NEBRASKA CAPITOL ENVIRONS COMMISSION

AGENDA

April 25, 2025

UDR25014- 14TH AND LINCOLN MALL INTERSECTION IMPROVEMENTS

ATTACHMENT B – Site Plan Options

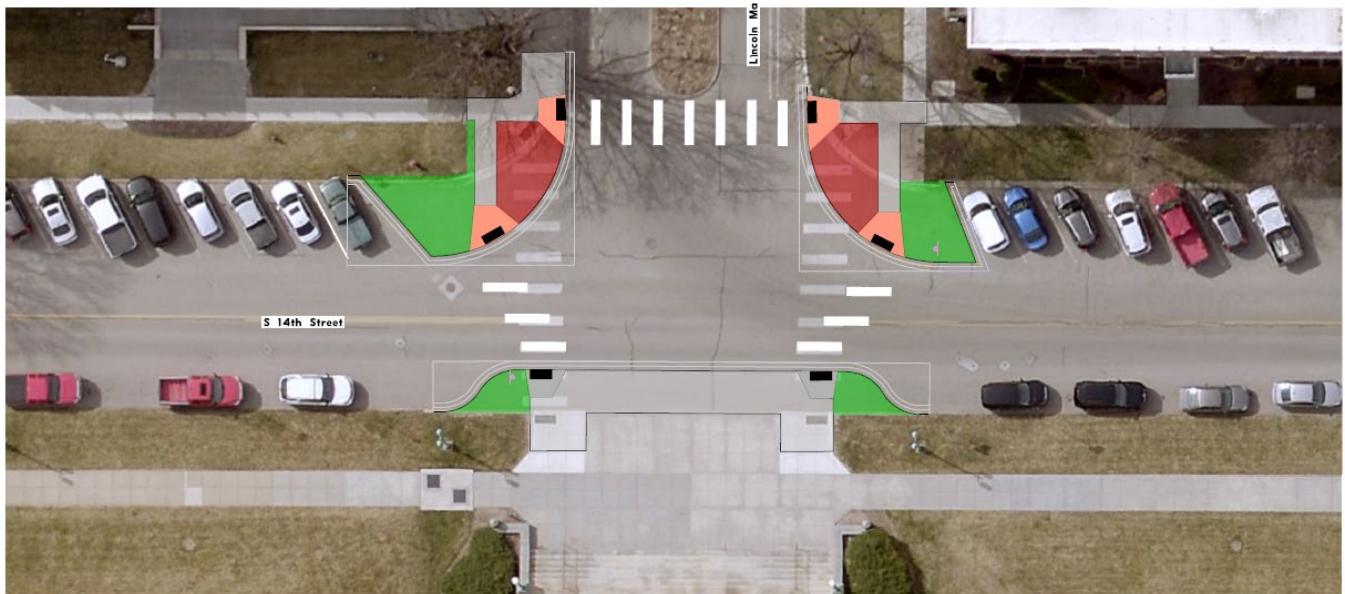
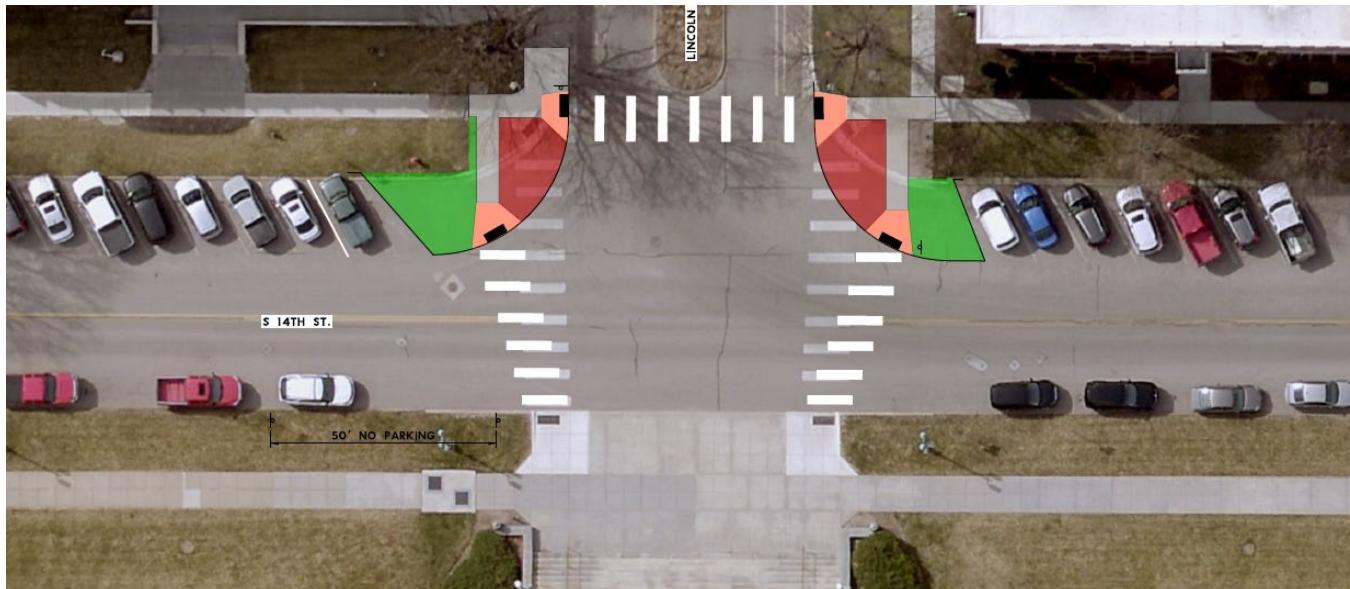
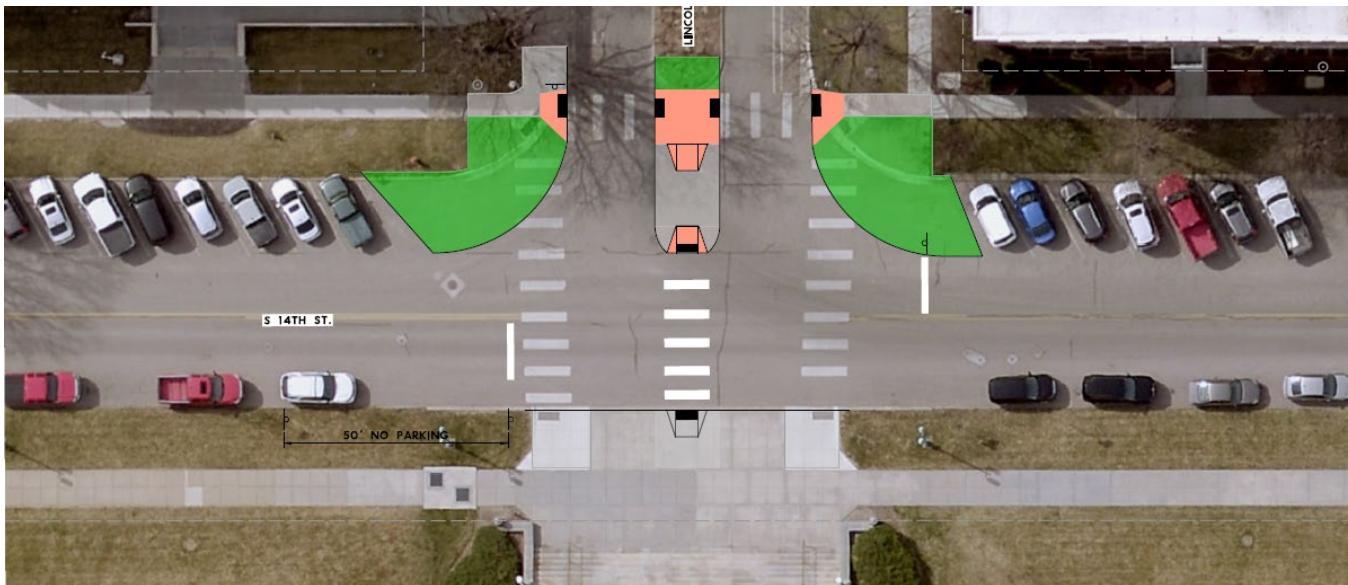
Concept B – This new concept eliminates the east bumpout. This results in a change to the angle of the east-west crosswalks, though said angle is still not ideal. This concept would result in the loss of a couple of parking stalls southeast of the intersection to improve visibility.

Concept A (original concept presented on 03/28/2025) – In this original concept from March, bumpouts are being proposed on both the east and west sides of S 14th Street. During the public hearing, some testifiers and commissioners expressed concerns about the bumpouts on the east side and the angle of the east-west crosswalks.

Concept B – In this new concept the curb line on the east side of S 14th Street remains unchanged, but two parallel parking stalls south of the intersection are to be removed to improve sight lines. The angle of the east-west crosswalks is less harsh compared to Concept A, but the crosswalks are still far from perpendicular to the curb line.

Concept C – Like Concept B, Concept C leaves the east curb line unchanged, resulting in the loss of two parallel parking stalls to ensure improved visibility. Additionally, this concept extends the center median at the east end of Lincoln Mall, allowing for a single east-west crosswalk that would run perpendicular to the street and be located in the middle of the intersection. This solution would require the consolidation of curb ramps along the Capitol Square curb line.

Planning staff is of the opinion that both Concept B and Concept C are viable solutions that would be more appropriate than Concept A when considering the needs of all relevant stakeholders.
